Model	Model Code	Model Type
BF175A	BAJJ,BAKJ	
BF200A	BAEJ,BAFJ	
BF225A	BAGJ,BAHJ

After Countermeasure Thrust Washer Failure

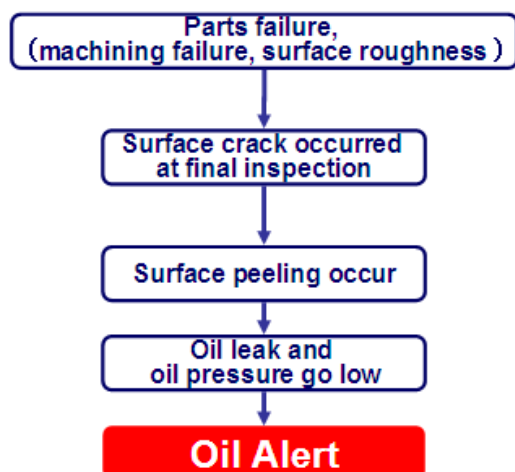
The engine loses oil pressure and the warning horn sounds. The crankshaft end play was found out of specification.

Thrust washer worn out due to insufficient lubrication for thrust washer material.

Countermeasure

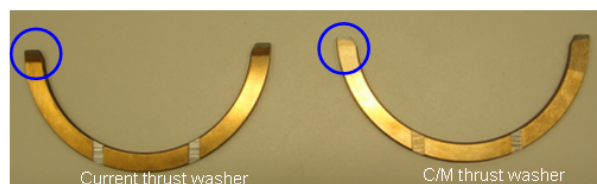
Change thrust washer material to improve wear resistance from CX4S to L10(Including lead).

C/M thrust washer changed material and surface roughness
